SUBJECT: REQUEST FOR ADDITIONAL INFORMATION ON THE 2009 PERFORMANCE
ASSESSMENT FOR THE SALTSTONE DISPOSAL FACILITY AT THE
SAVANNAH RIVER SITE

The U.S. Nuclear Regulatory Commission (NRC) staff has reviewed the "2009 Performance Assessment for the Saltstone Disposal Facility at the Savannah River Site," (PA) dated October 2009, and the associated documentation provided. This review is being conducted in accordance with Section 3116 (b) of the Ronald W. Reagan National Defense Authorization Act for Fiscal Year 2005, which requires NRC to monitor disposal actions taken by the U.S. Department of Energy (DOE) for the purpose of assessing compliance with the performance objectives set out in 10 CFR Part 61, Subpart C. The PA is an update to the Performance Assessment performed in support of the "Draft Section 3116 Determination, Salt Waste Disposal, Savannah River Site," dated February 28, 2005. The updated document is changed significantly and includes a much-improved format for readability and technical clarity. The staff acknowledges the effort taken to make the document easier to navigate with the use of section summaries preceding each section and appreciates the usefulness of stat

Figure 1: Moisture characteristic curves adapted from the PA and WSRC-STI-2006-00198

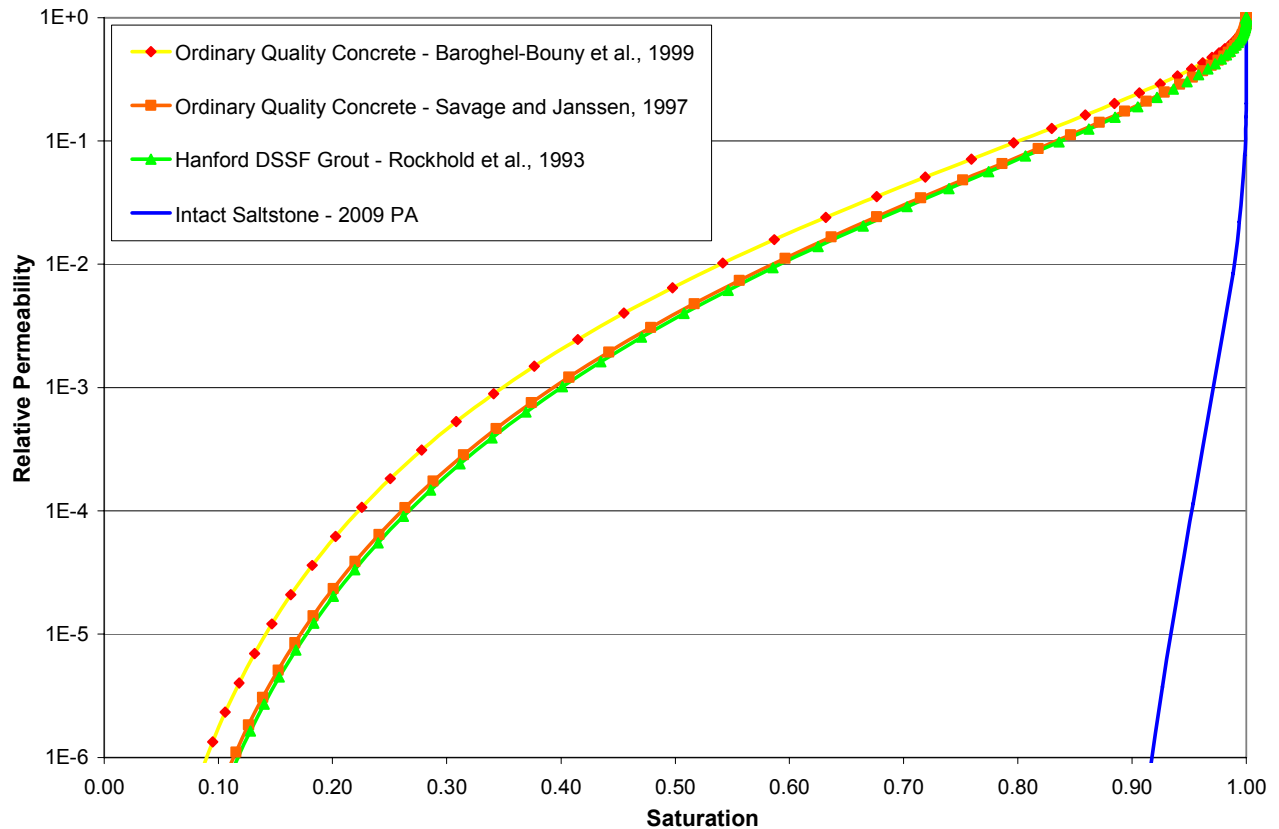
SP-3 Comment: The moisture characteristic curve for intact saltstone implemented in the PORFLOW model does not sufficiently account for experimental uncertainties and is inconsistent with literature results for material similar to saltstone and other cementitious materials.

The PA implements curves substantially different from those found in literature. For example, the curves in the PA are significantly different from the curves discussed in *“Hydraulic Property Data Package for the E-Area and Z-Area Soils, Cementitious Materials, and Waste Zones”* (WSRC-STI-2006-00198) (Figure 1). The moisture characteristic curves discussed in WSRC-STI-2006-00198, which were derived by Rockhold et al. (1993), Savage and Janssen (1997), and Baroghel-Bouny (1999) for different cementitious materials by different methods, all have very similar characteristics. The similarity of the curves is significant because the curve derived by

Path Forward: Provide additional justification for the moisture characteristic curve for intact saltstone implemented in the PA model by addressing the experimental sources of uncertainty described in the basis. Alternately, provide updated results of Cases A, B, C, D, the synergistic case, and the sensitivity case in Section 5.6.6.7 that use a characteristic curve for intact saltstone that is more consistent with results in the literature. Any updated analysis should be consistent with the response to SP-4.

Figure 2: Characteristic curves for the intact and fractured saltstone and concrete as adapted from the 2009 PA and SRNL-STI-2009-00115

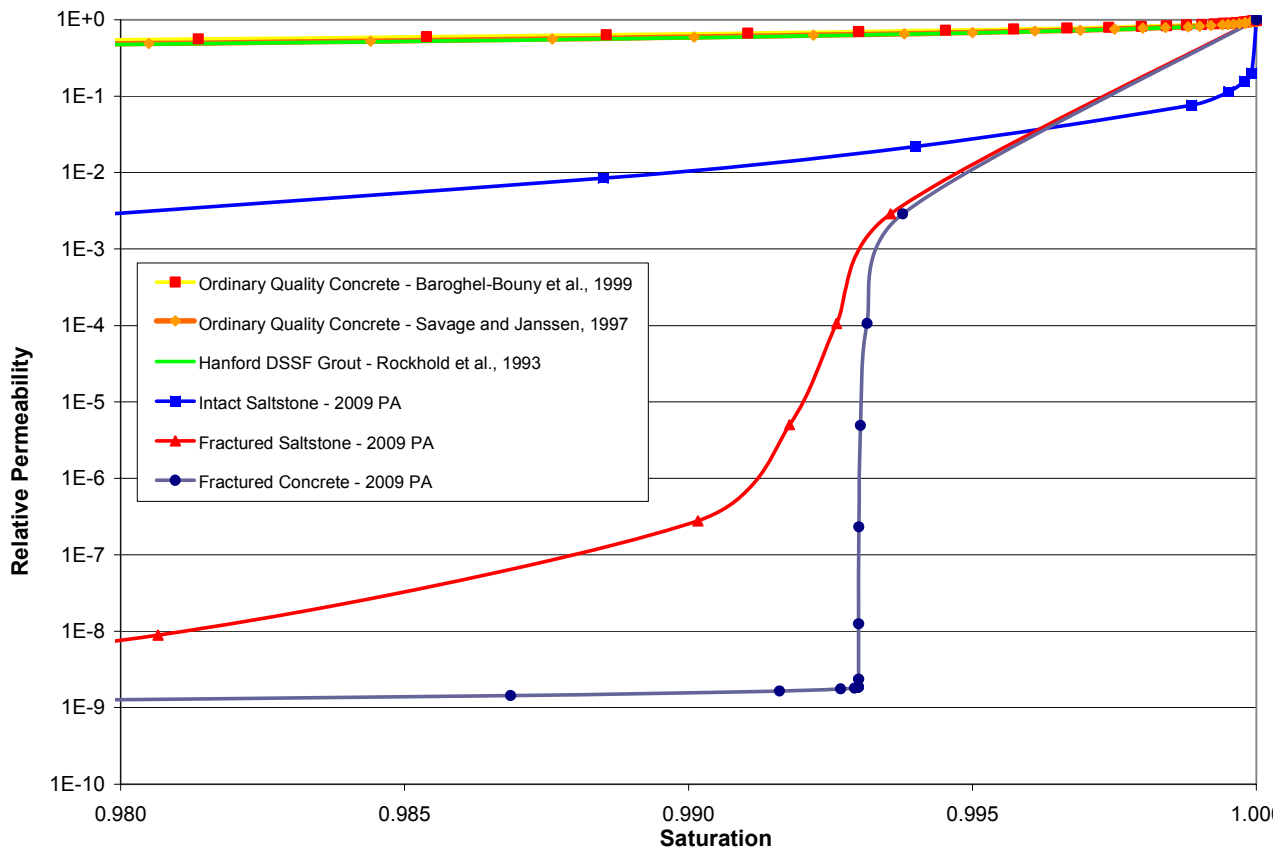
SP-4 Comment: Characteristic curves implemented in the PA are based on a continuum approach that does not reflect non-equilibrium flow.

Basis: The characteristic curves developed by INL (referred to in SP-3) were also used as the basis for the fractured saltstone and concrete characteristic curves (see Figure 2 below) that were developed in “*Numerical Flow and Transport Simulations Supporting the Saltstone Disposal Facility Performance Assessment*” (SRNL-STI-2009-00115). The authors discuss the use of an analytical approach developed by Or and Tuller (2000) to adapt INL moisture characteristic curves for cracked cementitious materials because experimental characteristic data for cracked vault concrete and saltstone grout are not available (SRNL-STI-2009-00115). However, use of moisture characteristic curves combined with coarse spatial and temporal averaging can result in an inadequate representation of non-equilibrium flow.

Path Forward: Provide additional support for the modeled flow through fractures. Model support could include field observations and laboratory experiments that verify consistency between numerical results and physical measurements.
